HAYSTACK OBSERVATORY

8 February, 2000

TO:	VSI meeting attendees
FROM:	Alan Whitney
SUBJECT:	Summary of VSI-H meeting results

The document 'Updated Draft Proposal for VLBI Standard Interface (VSI-H) Specification' dated 29 January 2000 served as the point of reference for the discussions at the meeting and is referred to in the summary below as the 'current' specification.

Figure 1: VSI-H Functional Block Diagram

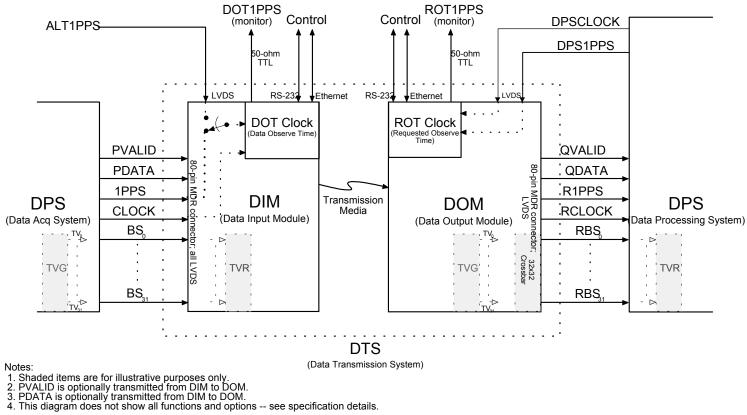
The VSI-H specification will be functional only and specify that 'any active DIM input bitstream must be mappable to any DOM output bit-stream. The VSI-H will not specify how this is to be accomplished. The functional block diagram may show a crossbar switch indicated as 'for illustrative purposes only'.

A new PVALID signal is defined at the primary DIM input connector, which may be used to mark valid data to the DIM; PVALID may optionally be transmitted to the DOM, where it can be "and'ed" with a DOM-internally-generated 'VALID' signal (which has the same definition as VALID in the 29 Jan document) to create QVALID, which replaces current VALID at the output of the DOM.
